**REQUEST**

Current Zoning: N1-A (neighborhood 1-A)  
Proposed Zoning: N1-E(CD) (neighborhood 1-E, conditional)

Approximately 1.988 acres located at the deadend of Pickway Drive, west of North Graham Street.

The petition proposes to develop two duplex buildings and two triplex buildings on parcels that are mostly vacant with one single family home.

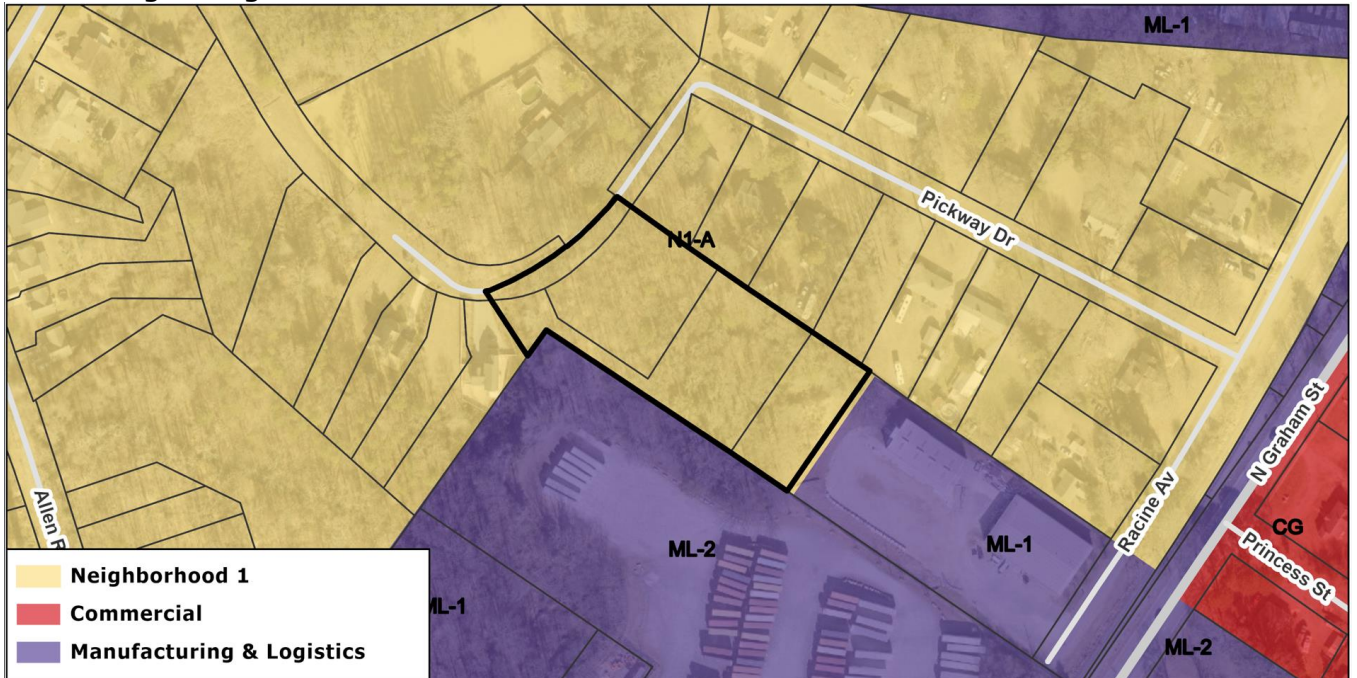
4. Specify **in the conditional notes what type of planting standards will be provided** in the rear setback against PID 04517220 **and along the side of lot 4C**. Consider adding conditional notes for planting standards that mirror the standards outlined for Class B or Class C Landscape Yards. ~~Add a 6' opaque wooden fence along the site's boundary against PID 04517220.~~

6. Modify the driveways shown for the triplex buildings to be compliant with Article 19.6.A.1.a.

8. Clearly distinguish and label each building as being on its own lot. Sublots for the individual units should be distinguished by dashed lines.
